**Analysis in Support of a
SEPA Threshold Determination
for the
Desert Claim Wind Power Project**

**RE: ANALYSIS IN SUPPORT OF A SEPA THRESHOLD DETERMINATION FOR
THE DESERT CLAIM WIND POWER PROJECT**

**DESERT CLAIM WIND POWER PROJECT APPLICATION AND
FINAL ENVIRONMENTAL IMPACT STATEMENT**

ANALYSIS IN SUPPORT OF A SEPA THRESHOLD DETERMINATION

FIGURE 1
ASC AND FEIS PROJECT BOUNDARIES
 EFSEC/DESERT CLAIM WIND POWER/WA

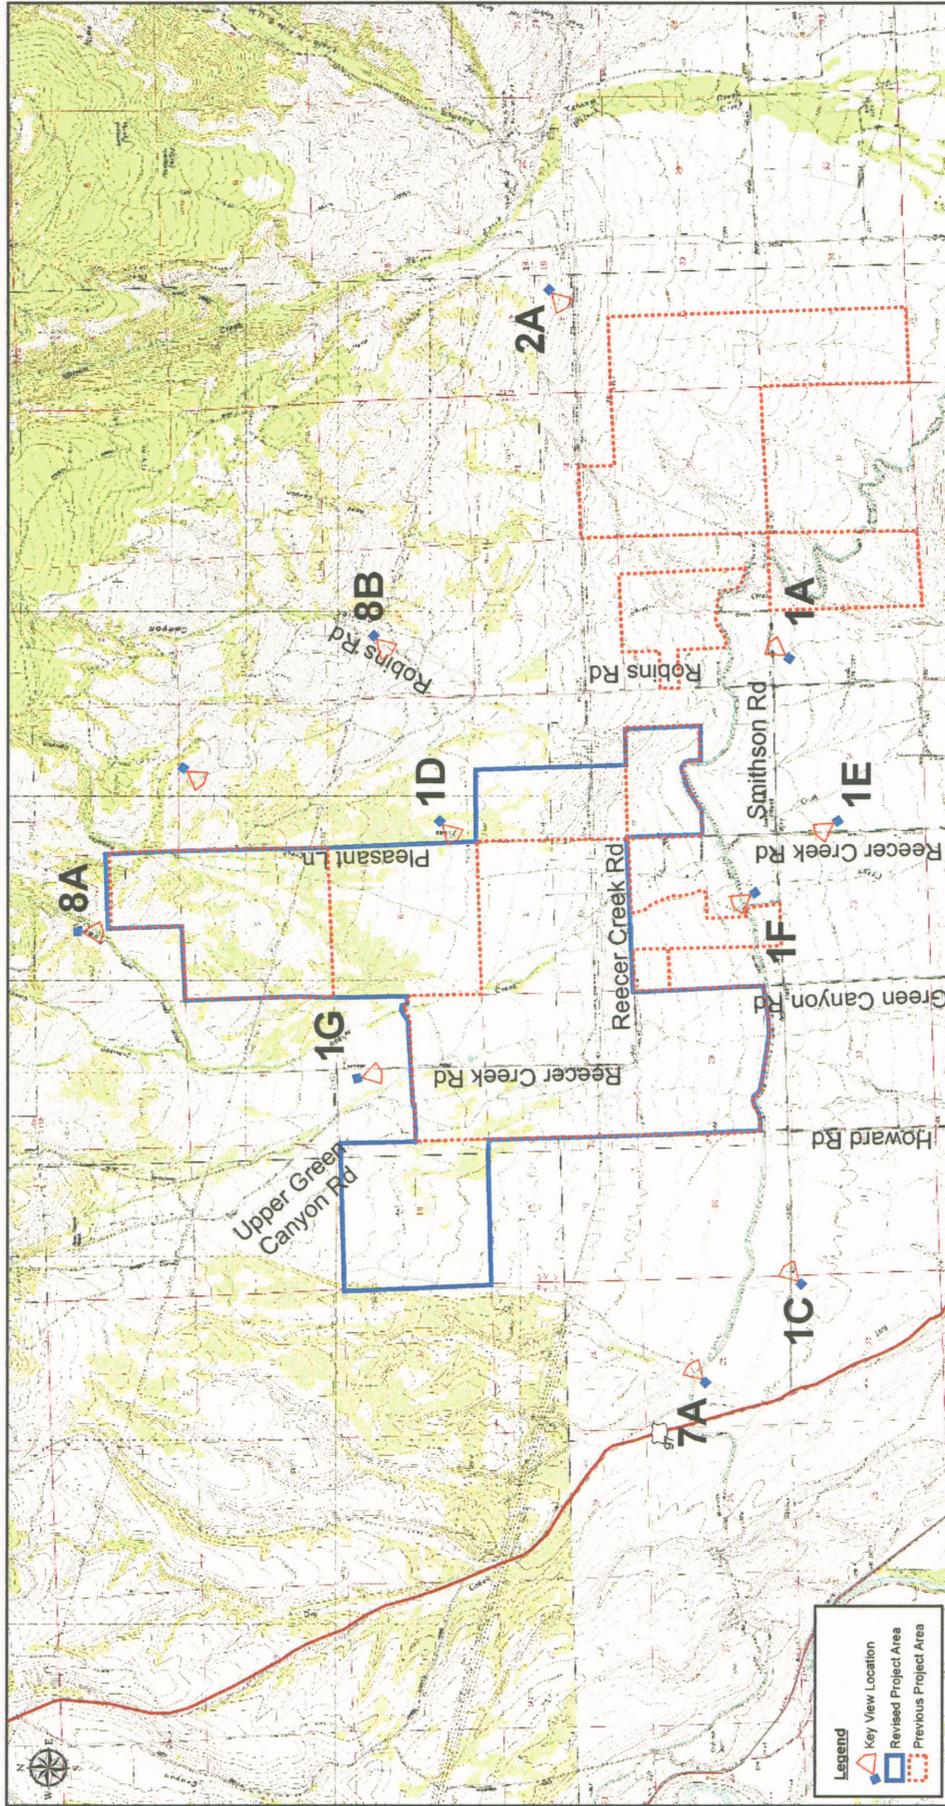
Figure 1 shows the proposed property boundary from the ASC and compares those boundaries with the boundaries shown in the FEIS. Viewshed sites are also shown in the figure. The major changes in this revision include a reduction in total acreage, consolidation of property lines resulting in a more contiguous site, a change in the number of towers, use of DNR land for some of the project, and changes in setbacks due to larger towers.

- View 1A which was rated as a “High” level of impact in Table 3.10-6 of the FEIS no longer has a view of the towers. This significant impact has gone away.
- Views 1E and 1F, also ranked as “High”, do not show the towers at nearly the scale as before, showing towers at half the original height due to greater distance from viewers, probably resulting in a new rating of moderate or low. (A formal rating was not done).
- View 1G, rated as a “high” visual impact, has not changed.

Tower Locations vs. Visual Significance – Views 1A, E, F and G were ranked “high” impact. After moving the site and towers eastward, views from 1A are Low (gone); views from 1E and 1F are probably “low” or “moderate”, and views from 1G are the same. Three of the four significant view shed impacts are reduced or eliminated. Impact ratings might change with the use of a 50mm lens.

FIGURE 2
ASC WIND TURBINE
EFSEC/DESERT CLAIM WIND POWER/WA

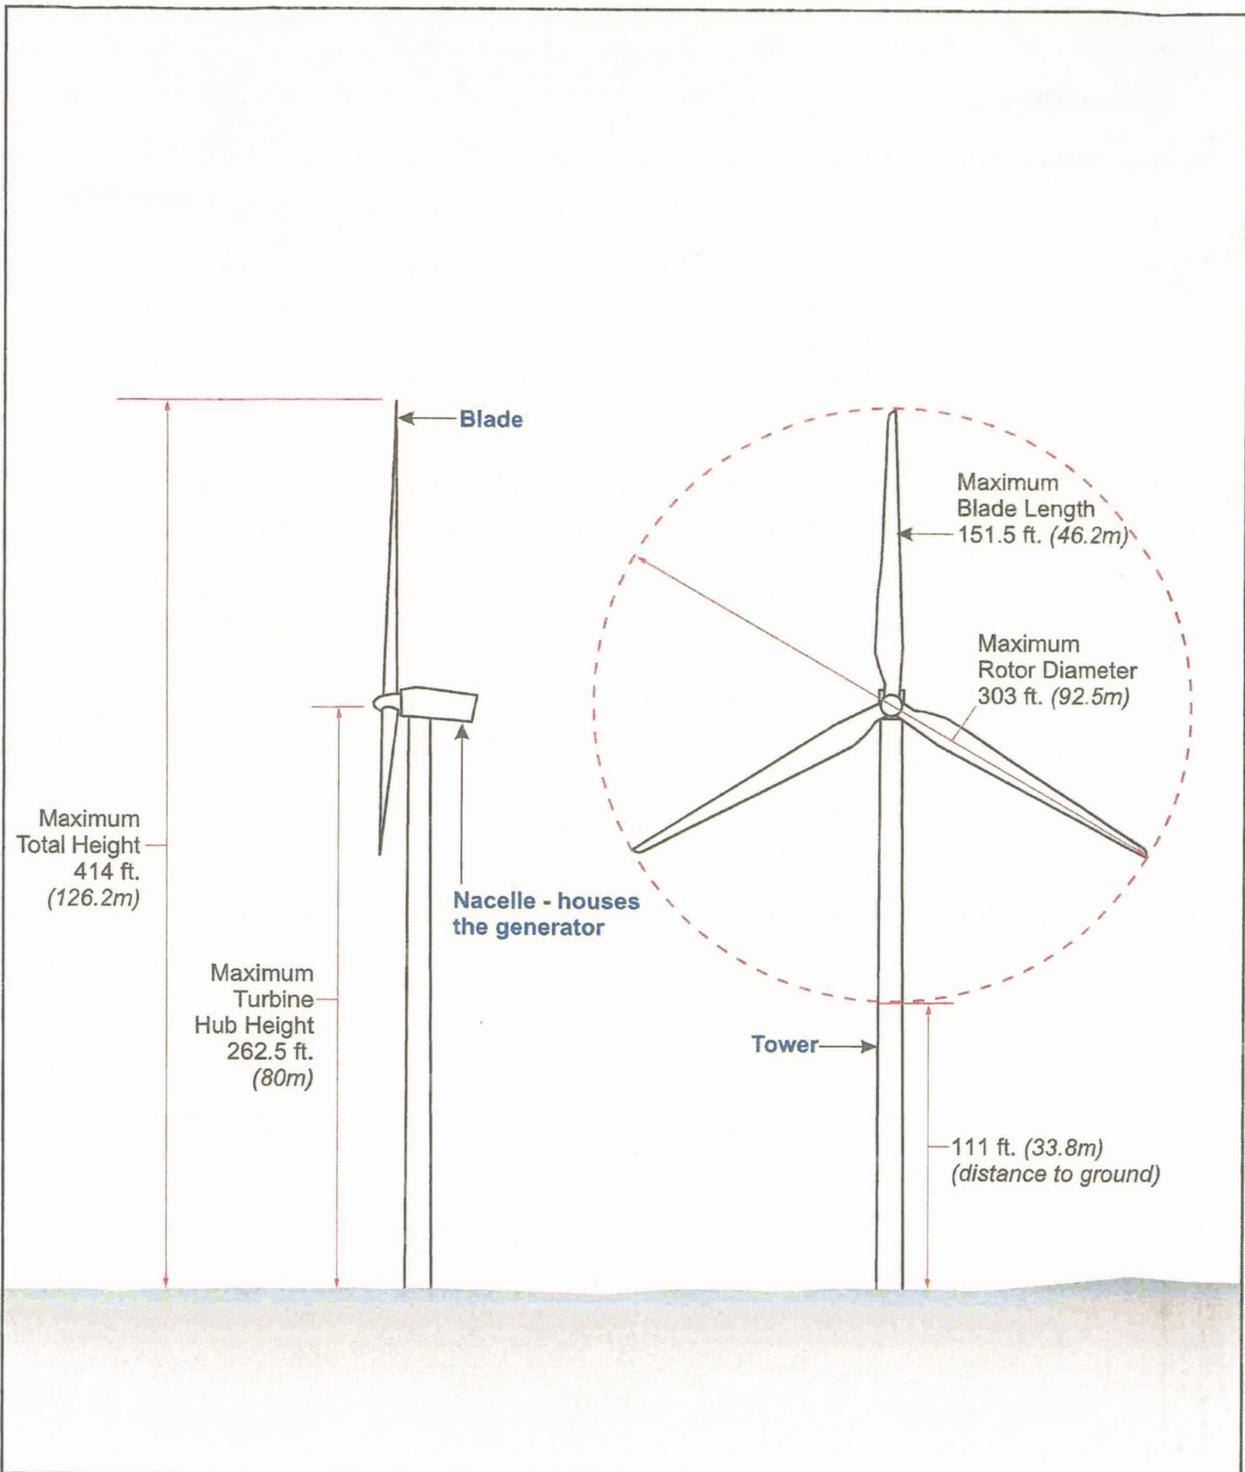
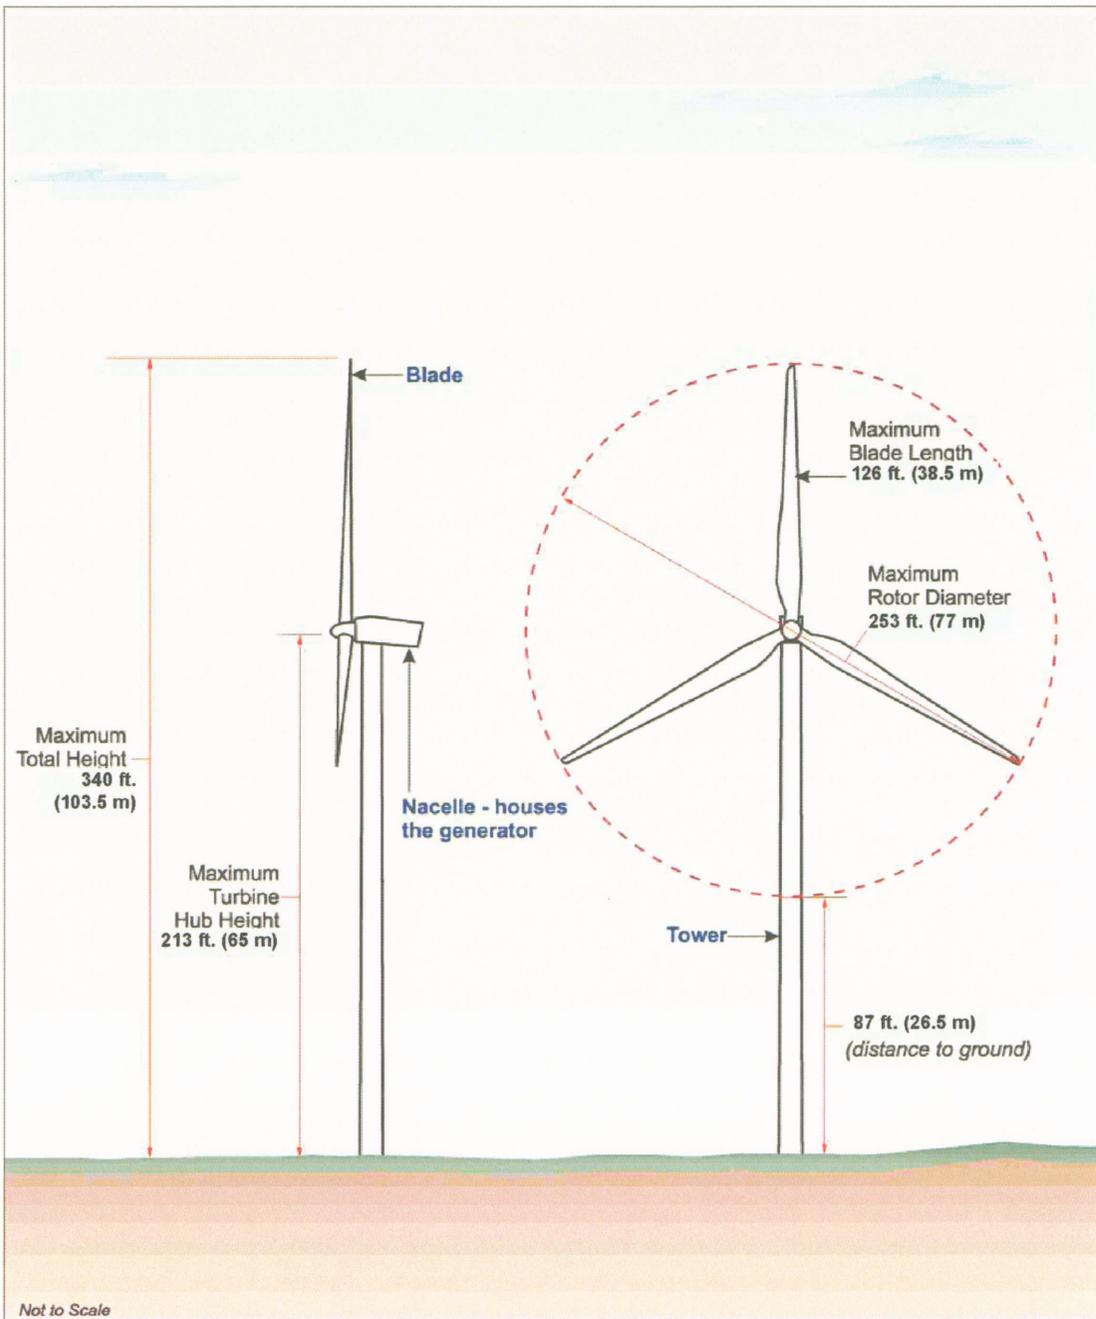
The project in the ASC has been revised since the FEIS and is a different project again. While it is similar to the “worst case” turbine design evaluated in the DEIS, it is bigger than the turbine design that was evaluated, finally selected in the FEIS, and denied by the County.

Now the applicant has revised the project again. They are proposing the original worst case large turbine size and are no longer proposing to build the turbine that the FEIS said would reduce impacts. This larger design was covered by the DEIS visual simulations so it is not “new information” requiring a SEIS, but it is different than the FEIS and has a turbine blade length, and ultimate turbine tower height, that are longer and taller than the examples included in the DEIS. With just an addendum, the public won’t have the opportunity to comment on this either, except through the EFSEC hearing process. The increases are not substantial, however, they do relate to aesthetics - and aesthetics appears to be the most significant issue the project has. Aesthetics was likely the main issue associated with its denial. Table 3 summarizes many of the project changes we have observed through the DEIS, FEIS and ASC. This is not intended to be a complete list.
